Re: Expansion of Many Rocks-Gallup
Pressure Maintenance Project No. 4
Case No. 3036, Order No. R-2700

Re: Expansion of Many Rocks-Gallup
Pressure Maintenance Project No. 4
Case No. 3036, Order No. R-2700
--- Amended Application ---

Reference is made to the amended application of Guyer Oil Company which seeks expansion of the Many Rocks-Gallup Pressure Maintenance Project No. 4, which was authorized under Order R-2700 and which was submitted by Core Laboratories, Inc., on April 27, 1965.

PROPOSED WATER INJECTION WELL
 GUYER OIL COMPANY
 NAVAJO NO. 1A-27
 MANY ROCKS GALLUP POOL, SEC. 27, T32N, R17W
 SAN JUAN COUNTY, NEW MEXICO

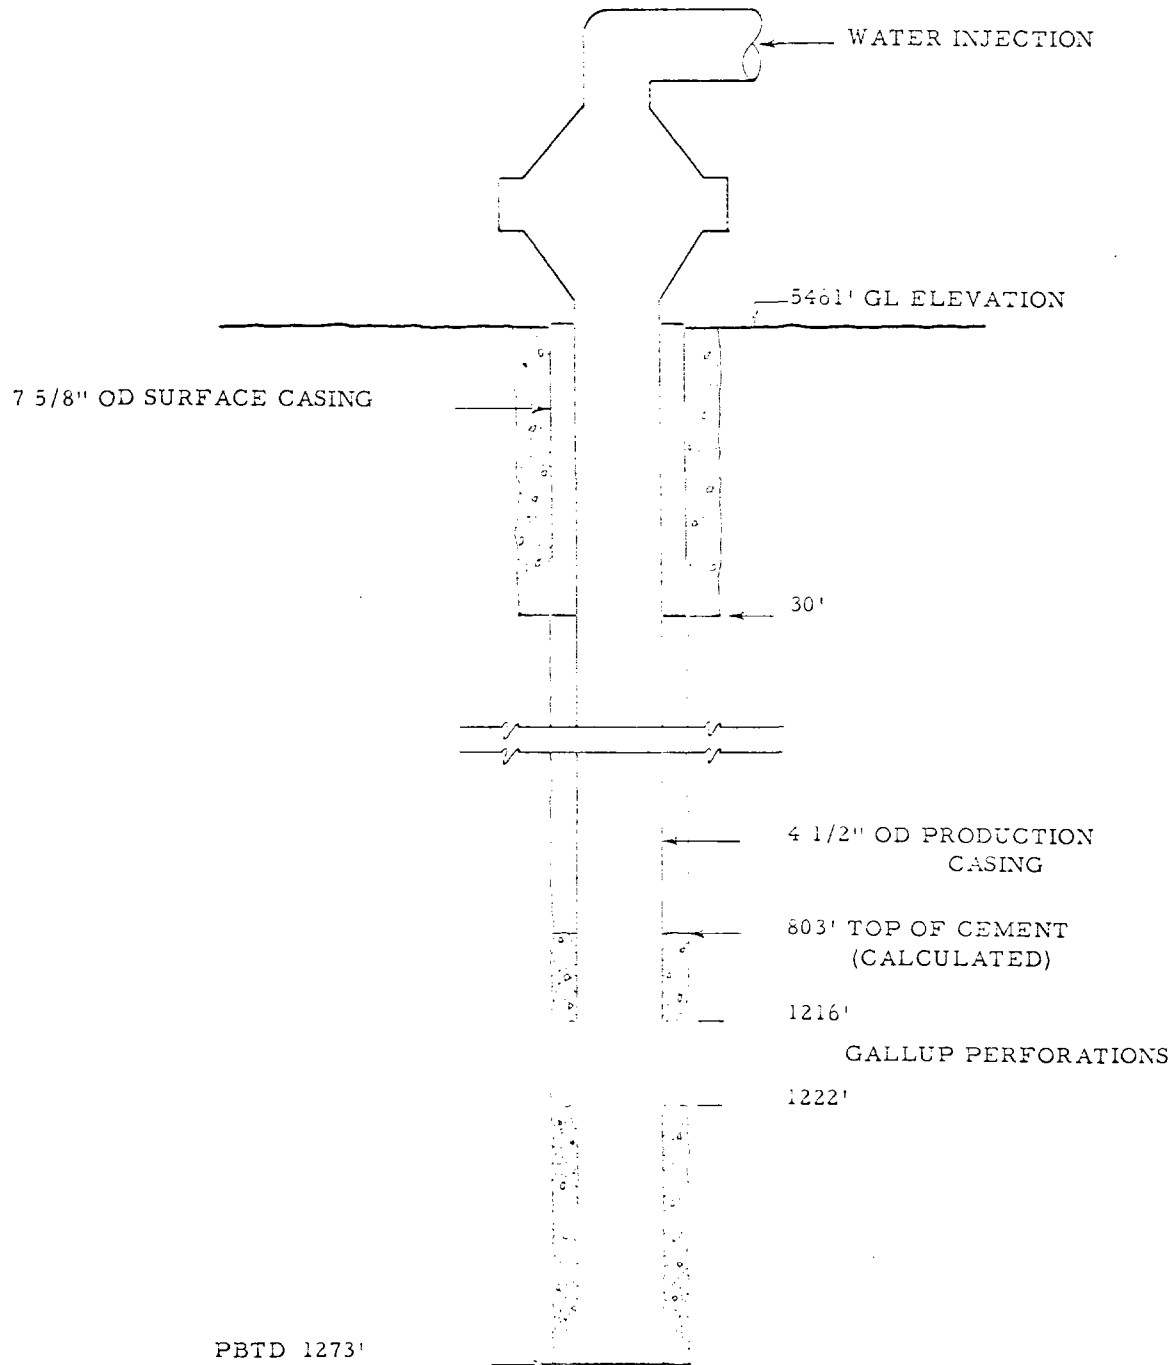
Referring to Exhibits D & E, it is not clear as to whether the annulus outside the 4½ inch O. D. casing will be open or closed, nor is there an indication as to whether a gage will be provided for in the event the annulus is closed. It is my thought that if a leak occurs in the casing, the annulus would be a very good source of indication soon after the leak developed. The observation of well head pressures and water injection rates would also be good indications but not necessarily conclusive. The letter of transmittal states: "The operator plans to observe well head pressures and water injection rates daily on each injection well throughout the life of the project." This language is not a definite statement that the observations will be made.

1. The operator shall make observations of well head pressures and water injection rates and pressure or fluid levels in the annulus outside the 4½ inch O. D. casing of each injection well throughout the life of the project at intervals of time not exceeding 7 days.
2. Actual corrosion rate shall be monitored at reasonably frequent intervals.
3. The water shall be handled under air-free conditions at all times which may be accomplished by adopting
